SERVICE INFORMATION

YS-078-06

SUBJECT: FC9C Modulating Furnaces With ECM Motor Control Board
S1-03109153000

Slightly Crimping Fuse Holder Sockets With Pliers For Tight Fit

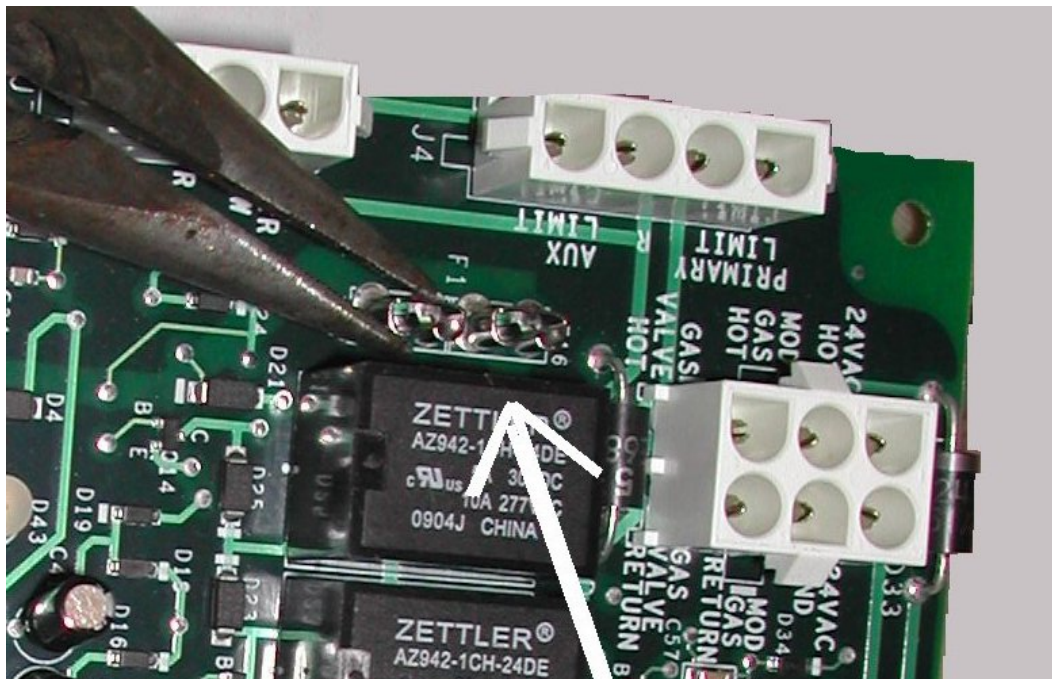
Some boards for the ECM modulating furnace may contain the incorrect fuse socket terminals. Because of shipping, handling or furnace vibration, the fuse socket may allow the fuse to become loose resulting in an Error Code 4, Open Limit or Open Onboard 24 VAC fuse. Note: The LED fault light is powered by 120 VAC on this board.

Please instruct the installing contractors to tighten the fuse terminal socket when installing the furnace on new installations.
